SMT Corpus

Request for Plat Waiver for Wastewater Infrastructure

Planning Commission Meeting
January 11, 2023

Nearest Wastewater Connectivity

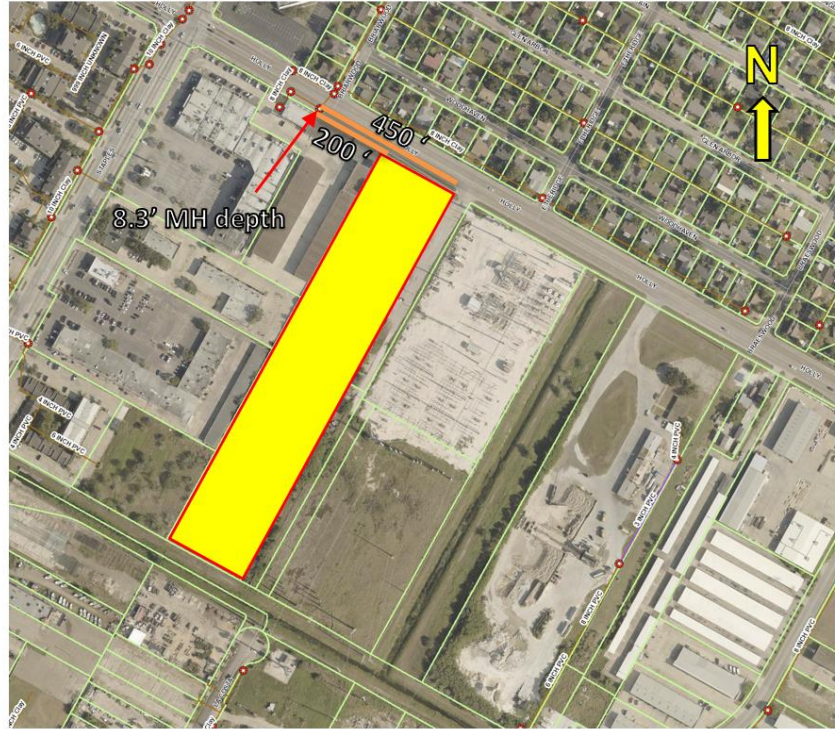
1. Wastewater service is reasonably accessible for this area as the nearest wastewater connectivity is around 200 feet away, which would be a 450 foot installation to include the full frontage. Per UDC section 8.2.7.d.ii:

Staff recommends approval of the waiver for the construction of wastewater infrastructure for SMT Corpus.
